**UMMC PROJECT NO. 409-007
FIRE PROTECTION CENTRAL CORE
UNIVERSITY OF MISSISSIPPI MEDICAL CENTER
JACKSON, MISSISSIPPI**

Addendum No. 1

August 5, 2026

This addendum forms a part of the contract documents and modifies the original plans and specifications dated June 12, 2026.

1
sheet no.
S102
of

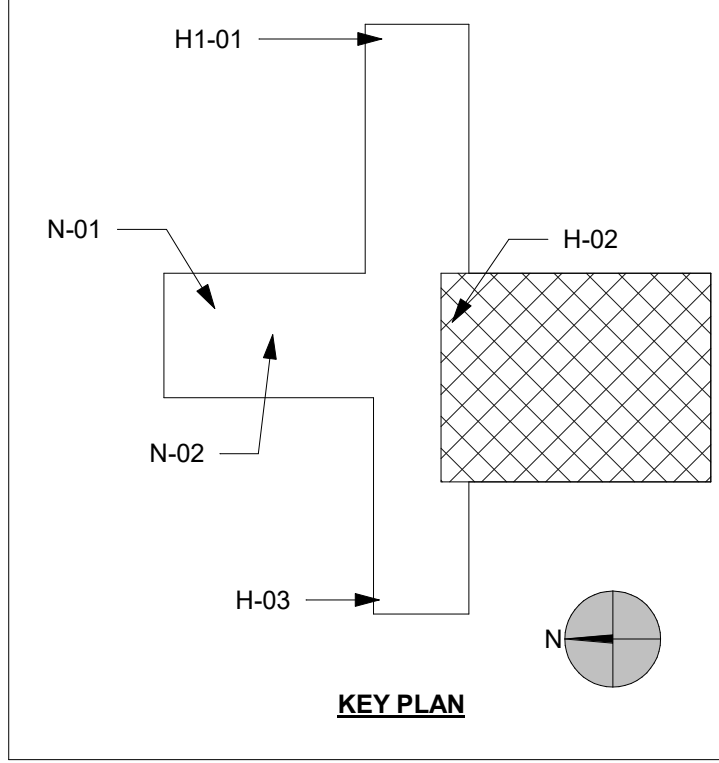
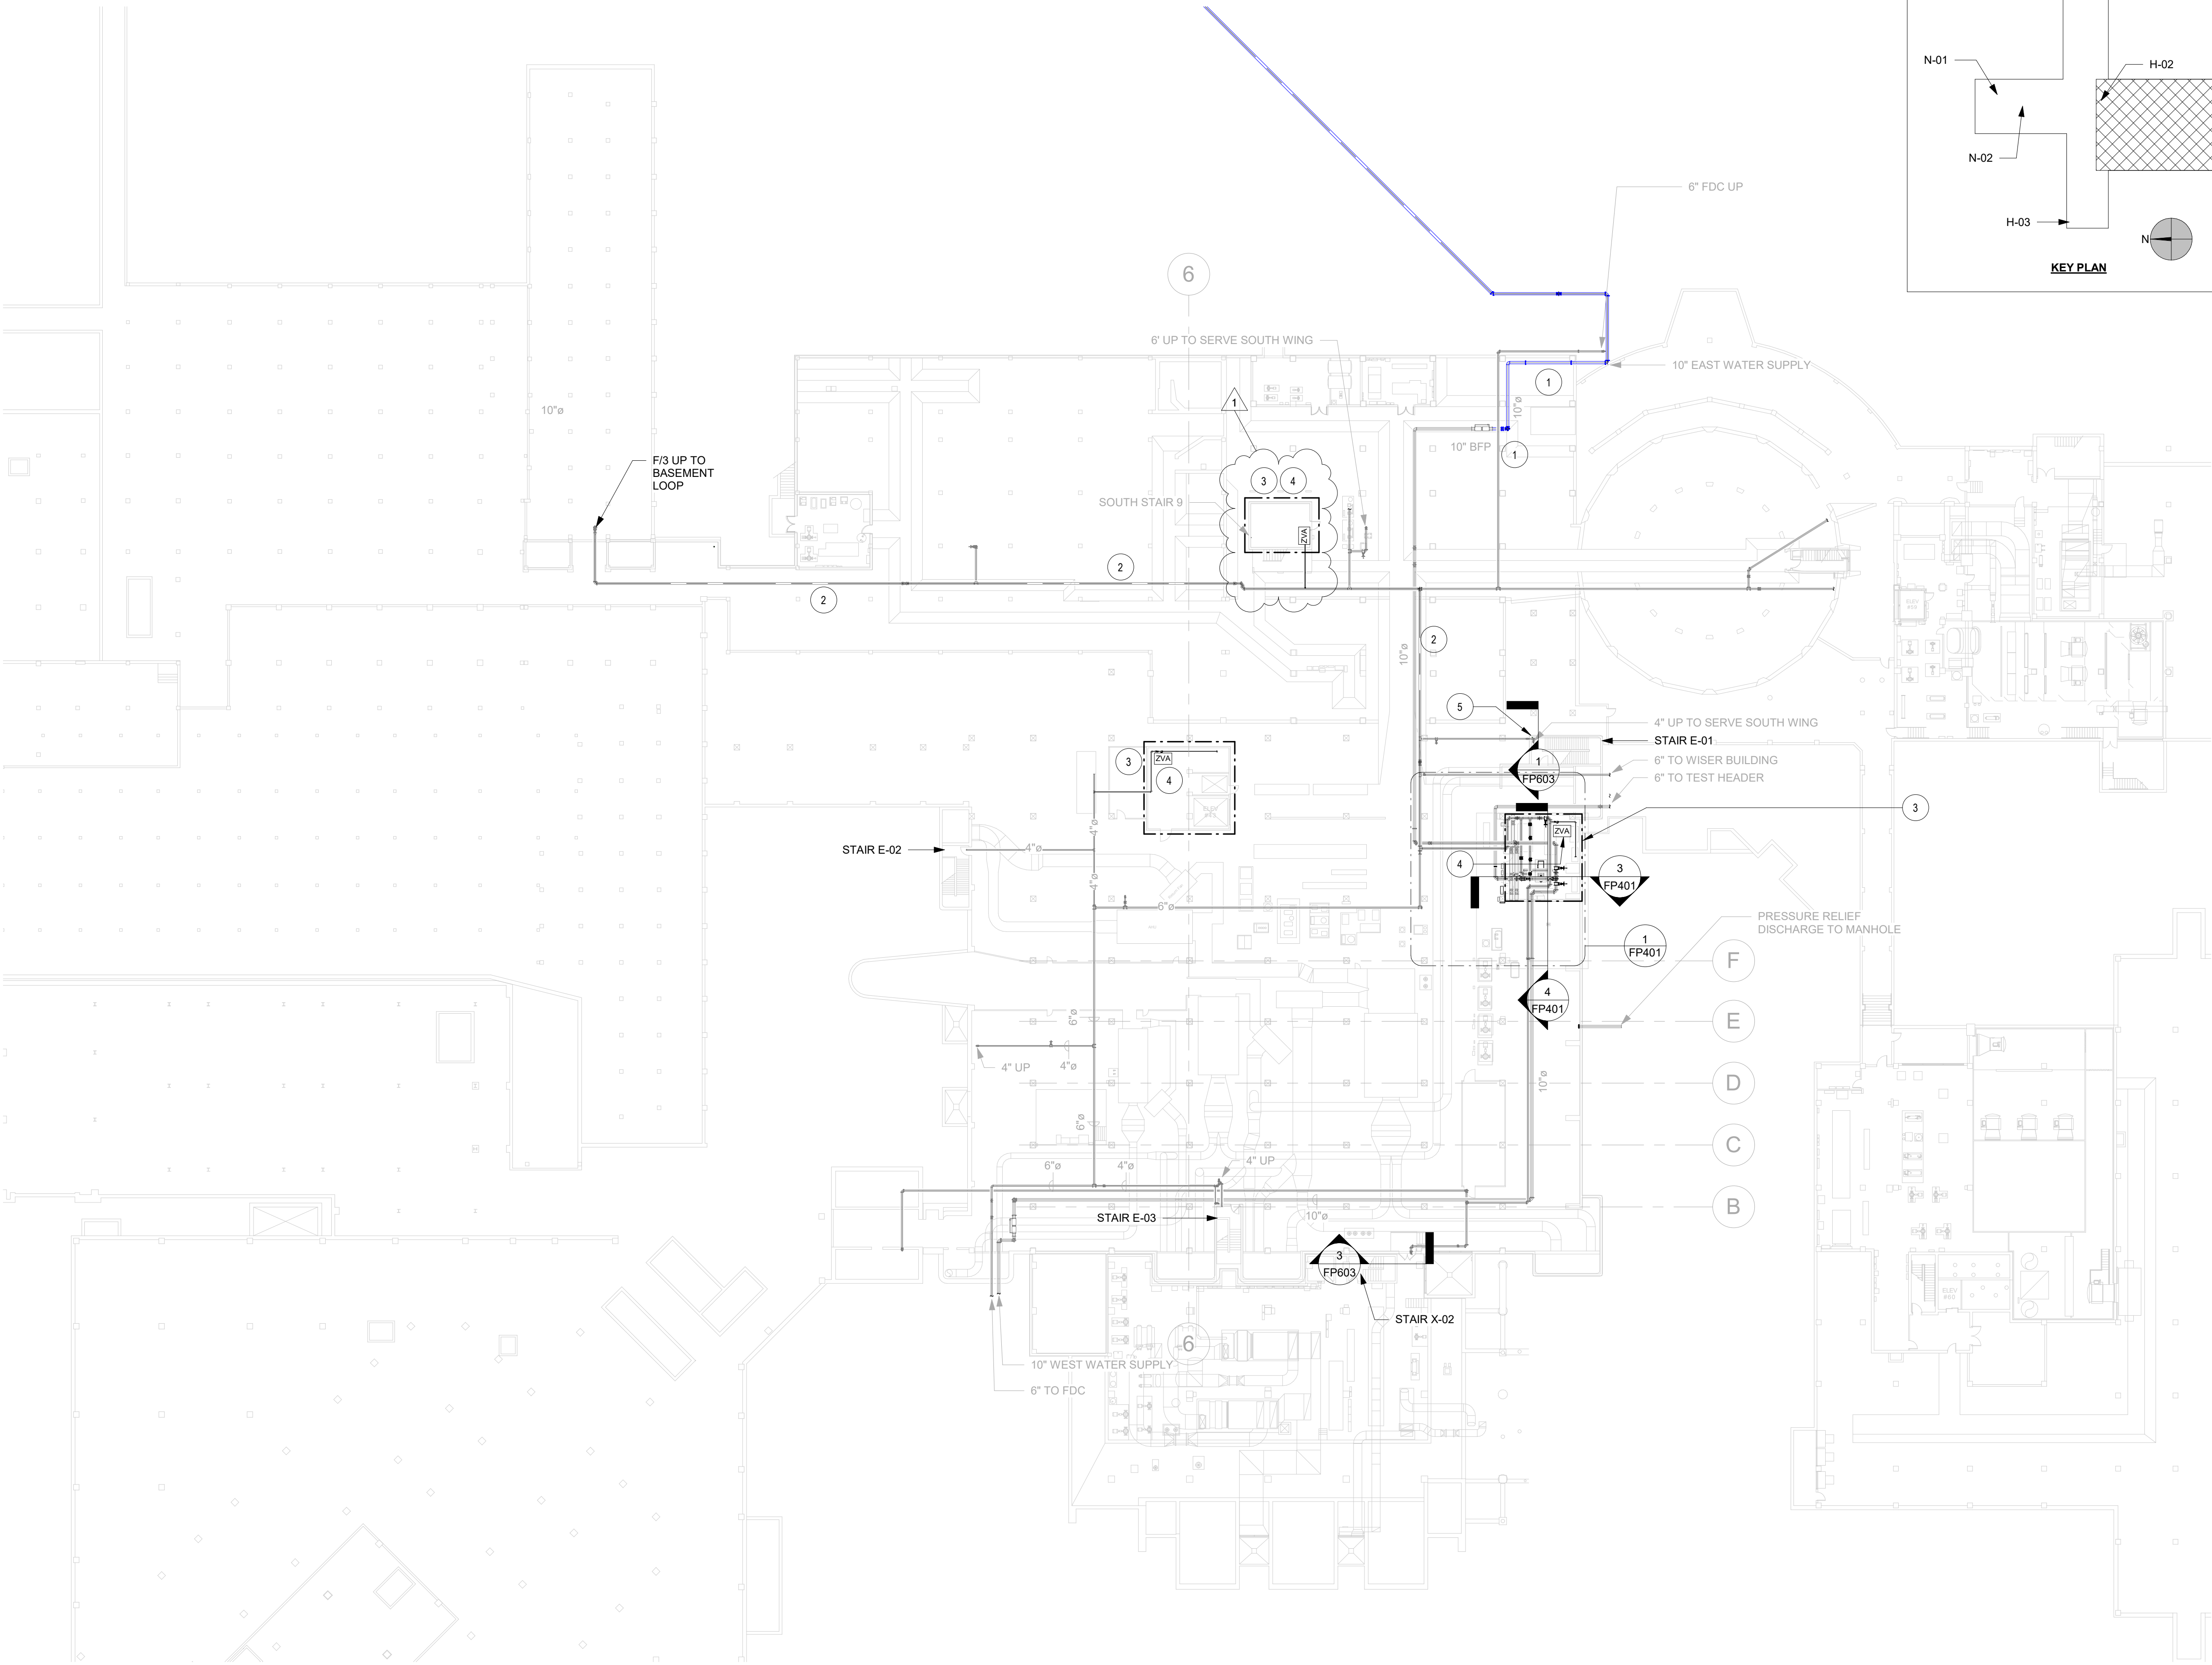
Item 1.6: Structural Drawings S101 And S102 for Alternate #1

Add: These two attached Structural Drawings.

sheet no.
FP201

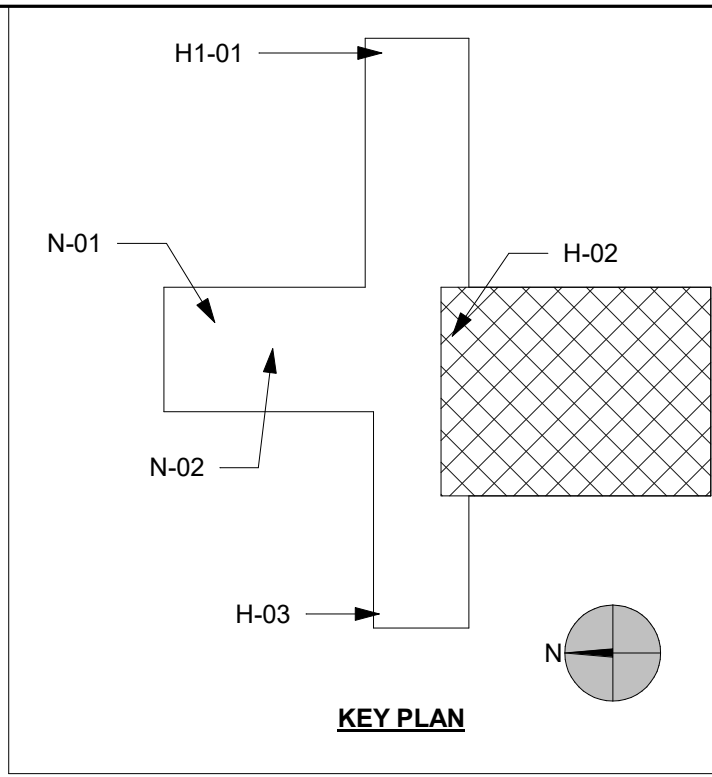
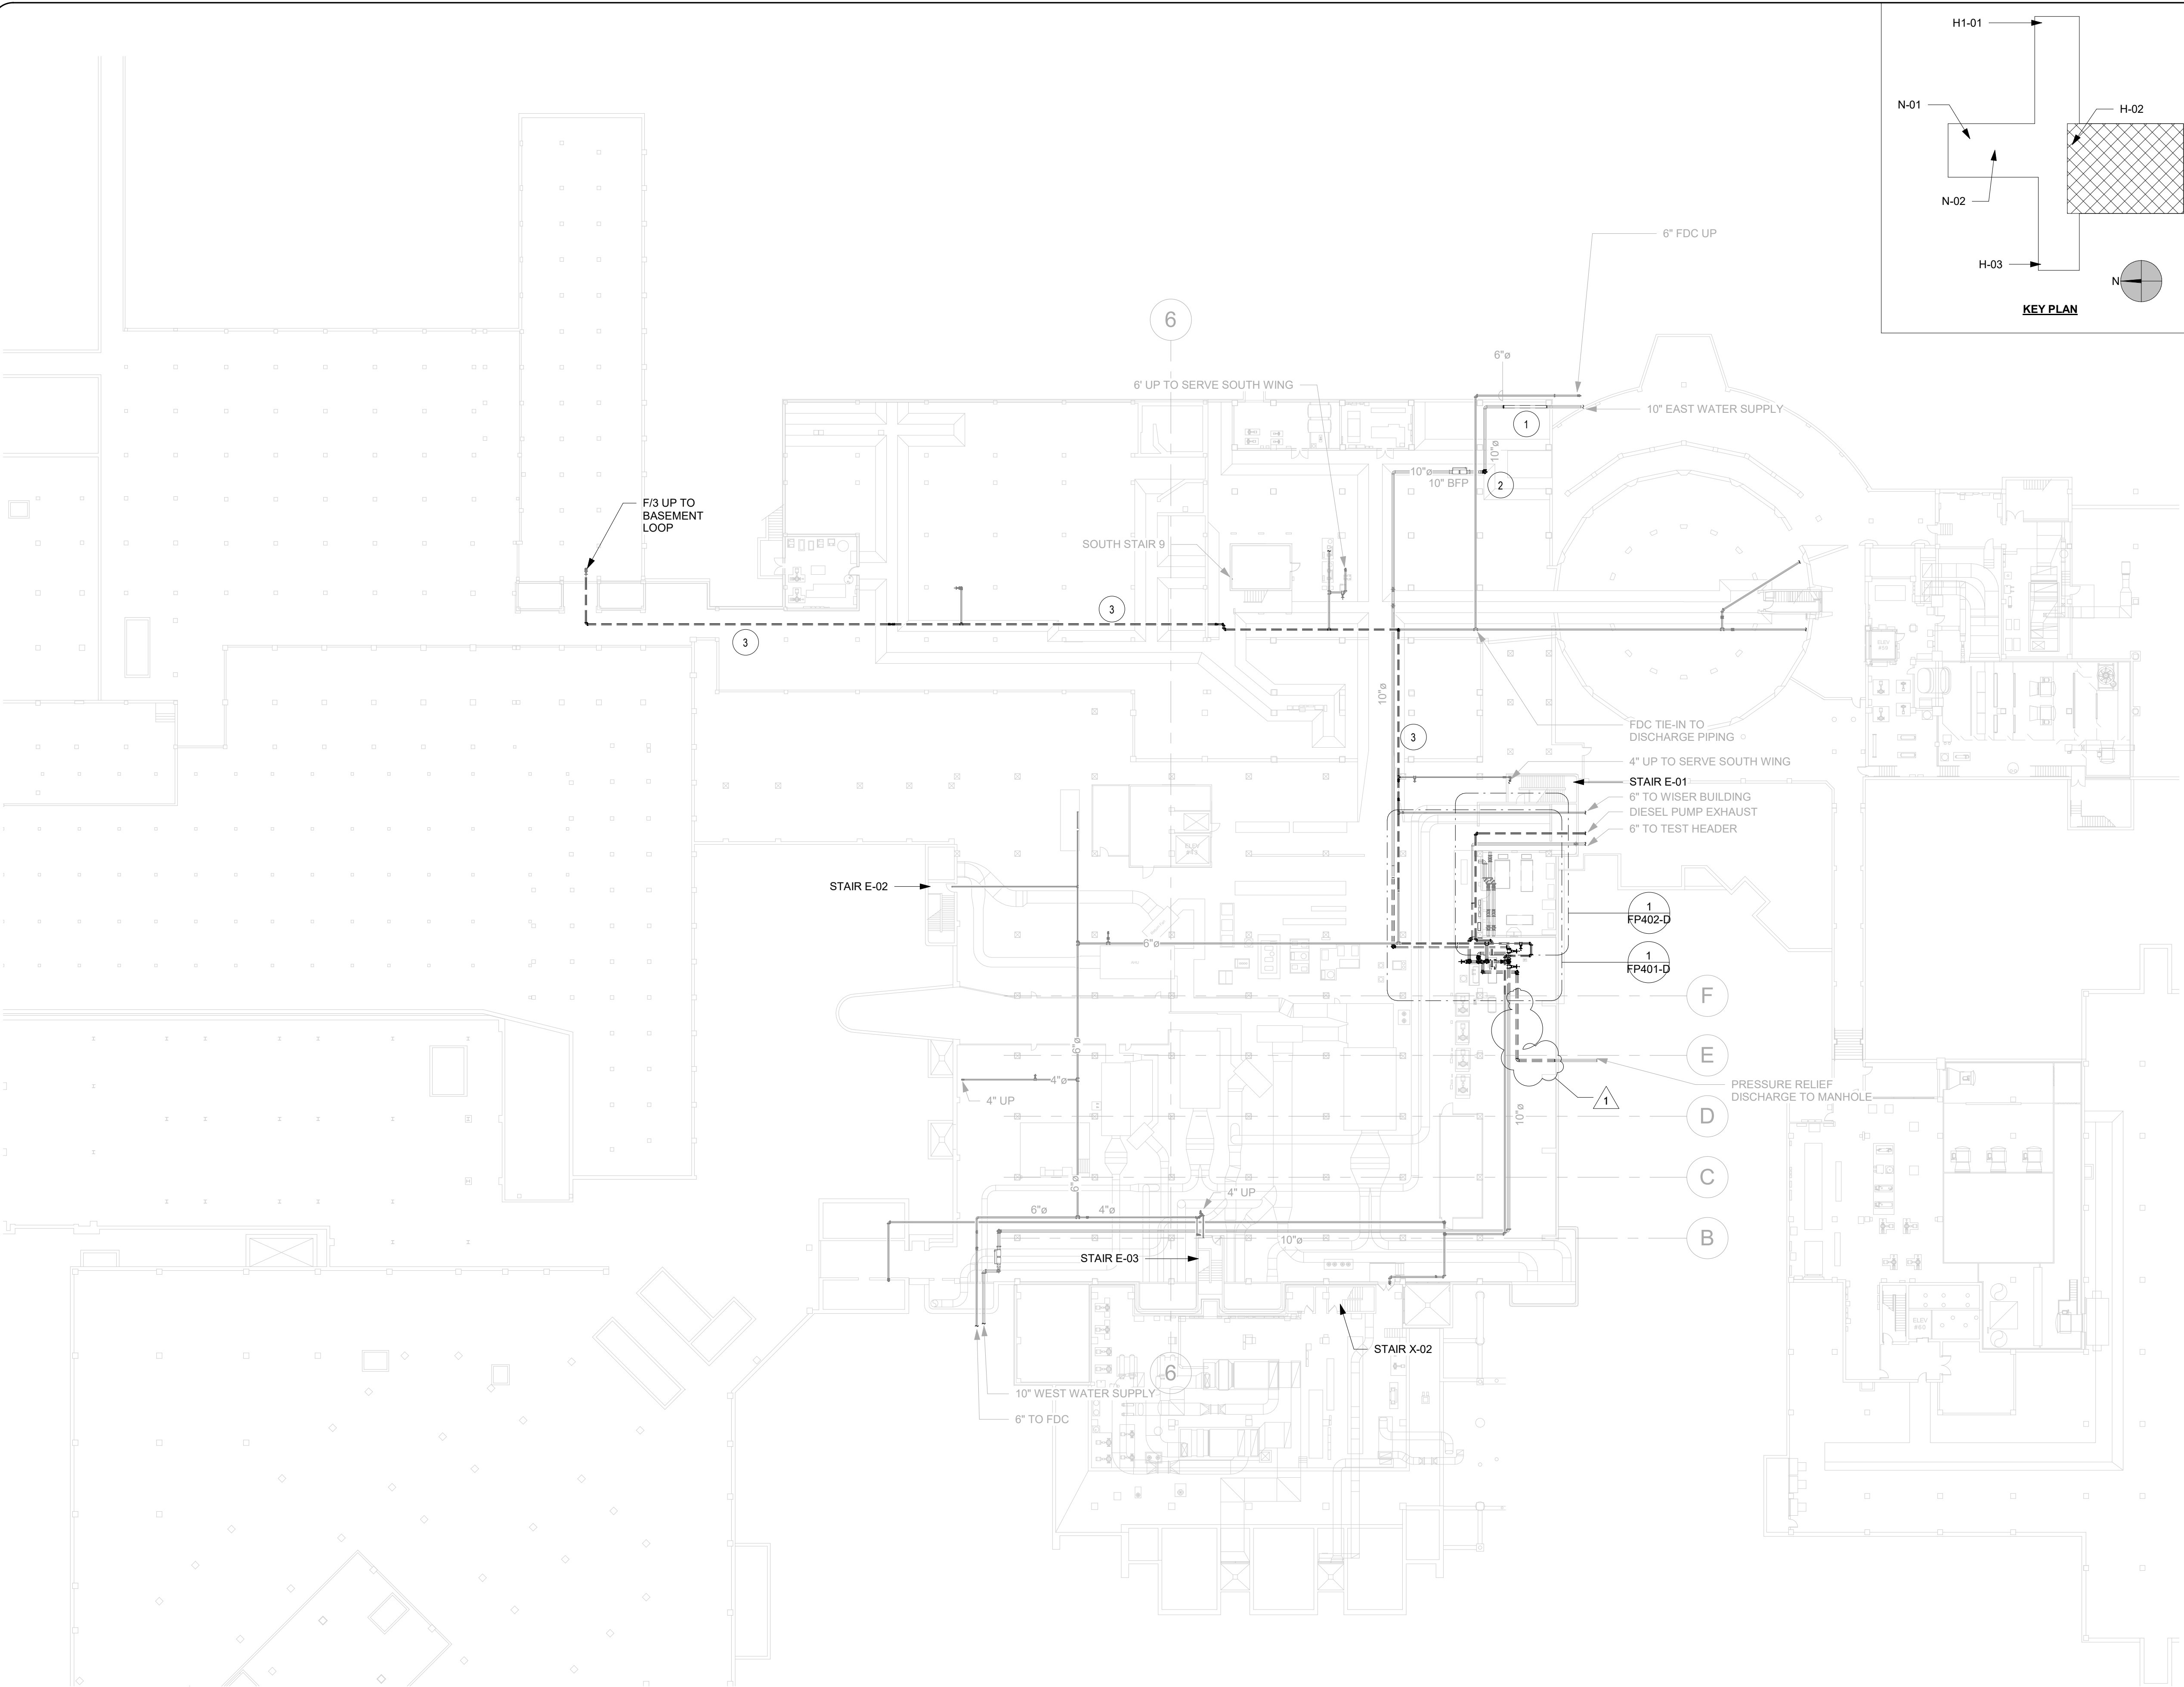
- A. Sheet FP201, Sub-Basement Overall New Work:
 - 1. New sprinkler zone scope boundary added.
- B. Sheet FP201-D, Sub-Basement Overall Demolition
 - 1. Pressure relief drainpipe demolished back to exterior wall.
